**Chemung County Stormwater  
Construction Inspection  
Erosion and Sediment Control**

<b>Project Name</b> CDS Monarch	<b>Date</b> 5-30-19
<b>Location</b> Maple Ave. City of Elmira	<b>Permit #</b> NYR11C547
<b>Weather Conditions</b> overcast, mild	<b>Entry Time:</b> 11:33 am
<b>On-Site Representative Present:</b> maintenance staff	<b>Exit Time:</b> 11:54

PROJECT: CDS Monarch  
City of Elmira  
Municipal Construction Insp.  
May 30, 2019

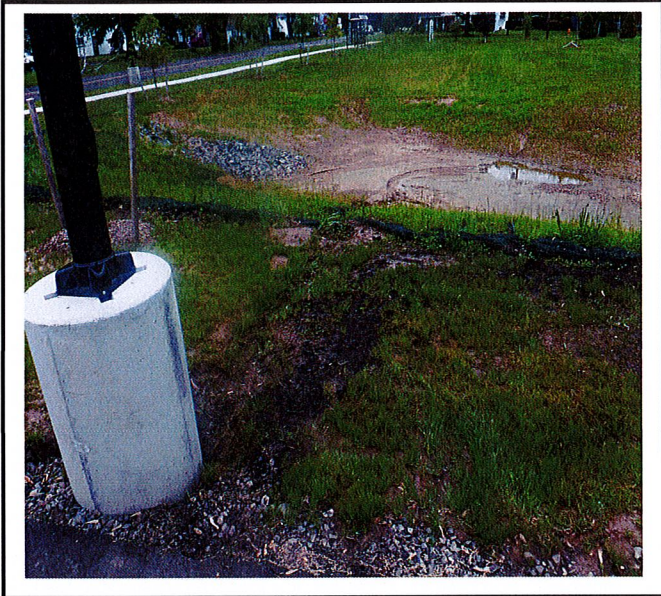
<b>Corrections Needed:</b>
-Major erosion is occurring off the parking lot into the forebay. This erosion needs to be repaired and sediment cleaned out of basin.
-Everywhere that compost sock was removed needs the mulch raked flat AND the erosion control blanket laid flat and re-stapled.
-Check dam in the basins are not installed correctly.
-Erosion is occurring around the catch basin on the north end of the property.
-Stabilization is not consistent around the property.
-All items noted in City letter dated 1/14/2019 need to be addressed.

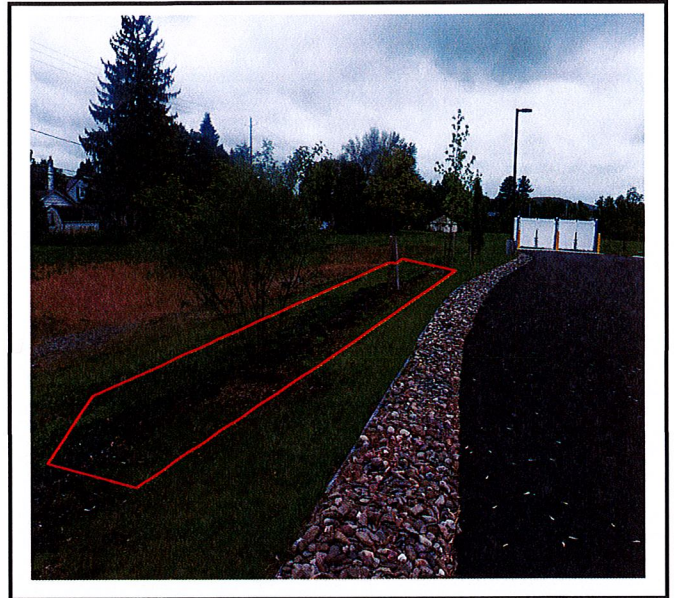
Erosion continues off from parking lot. Sediment will need to be removed form basin.

All areas where compost sock was removed need to be raked flat AND the erosion control blanket stapled flat onto the slope.

Check dams not installed correctly.

Erosion is occurring around catch basin. Grading needs correction.
